SAVANNAH HARBOR EXPANSION PROJECT CHATMAN
COUNTY, GEORGIA AND JASPER COUNTY, SOUTH
CAROLINA: FINAL GENERAL RE-EVALUATION RE-
PORT AND ENVIRONMENTAL IMPACT STATEMENT
JANUARY 2012

THE CORPS' FINAL GENERAL RE-EVALUATION REPORT AND
ENVIRONMENTAL IMPACT STATEMENT

APPENDIX N: Record of Interagency Coordination

Record of Interagency Coordination

Figure 5-1 Locations of the Surface Salinity 0.5 ppt 50% EV under Existing Conditions
(Courtesy of the USACE Savannah District)

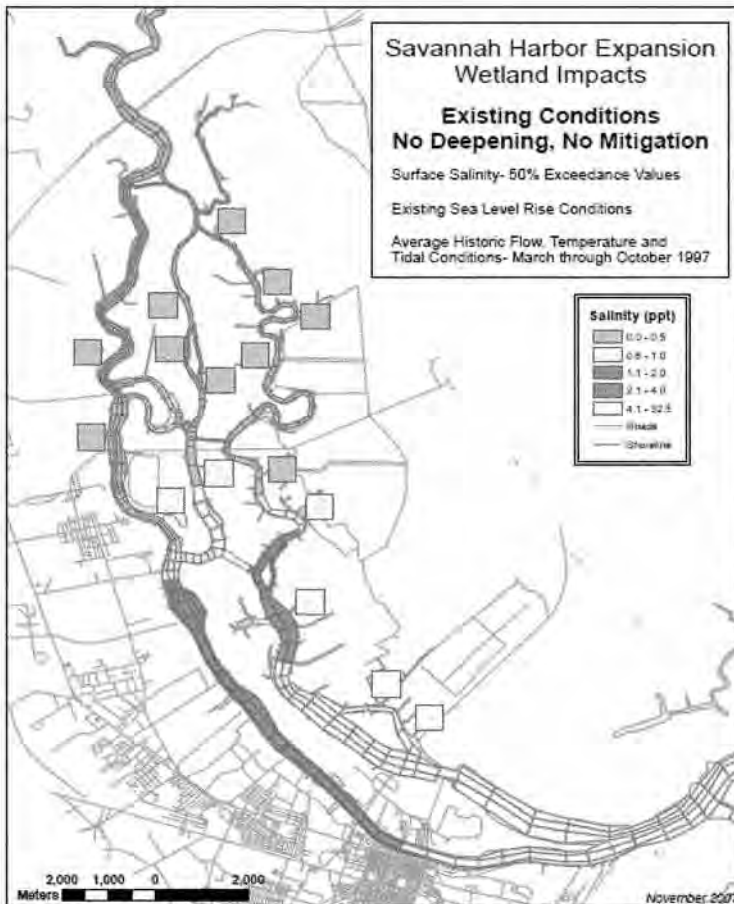
5.1.1.1, Impacts from Excavation of Wetlands, page 5-1. The text states that the first two entries in Table 5-1 are Refuge lands, but the table labels the first three entries as Refuge lands. Figure 5-1 is illegible, but appears to depict the Kings Island Turning Basin along with another area for dredging. It is unclear where the third area of excavation is located (we believe 96+000 to 97+000). Figure 5-2 appears to depict the non-Refuge portion of excavation from 86+000 to 88+500, but it too is unclear. A proximity map would help locate these areas in relation to the Savannah NWR.

Figure 5-4 Wetland Predictions based on 0.5 ppt 50% EV under Plan6A
(Courtesy of the USACE Savannah District)

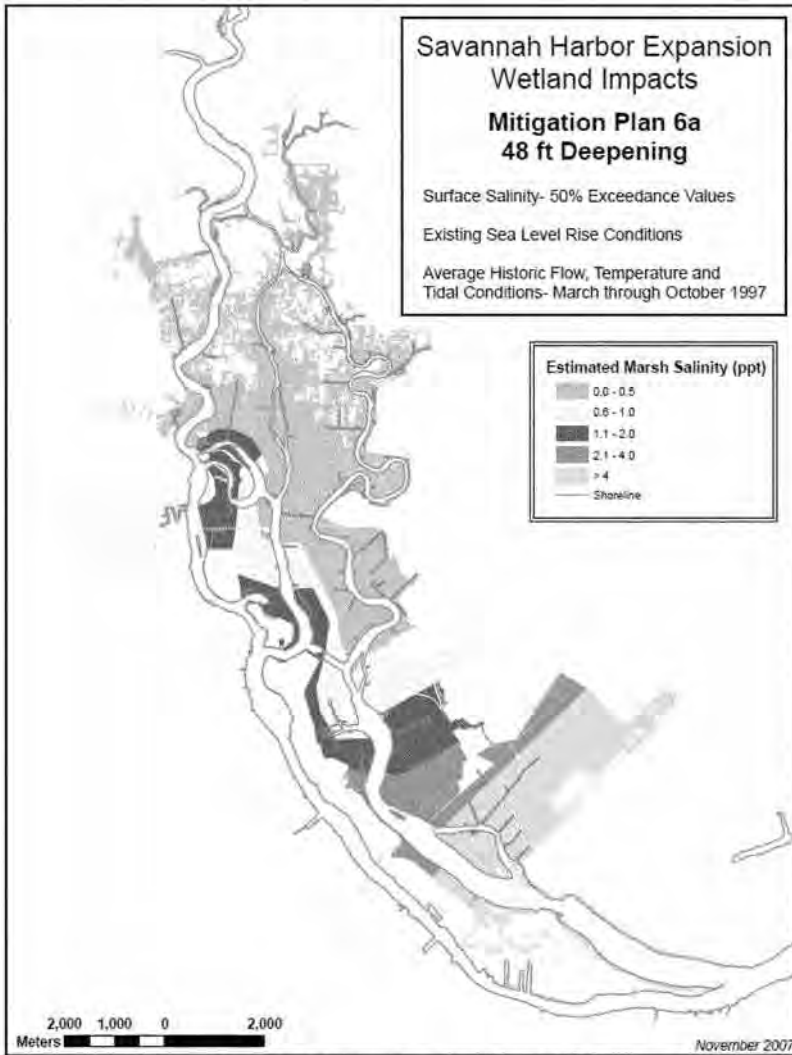
5.1.1.2, Impacts from Excavation of Wetlands, page 5-6. The discussion in the opening paragraph references Figure 5-52 as CDF 1S; however, Figure 5-52 is a picture of Old Fort Jackson (on p. 5-134). We believe the correct reference is to Figure 5-4 on page 5-7.

Response: Concur. The text on Page 5-6 has been revised to refer to Figure 5-4.
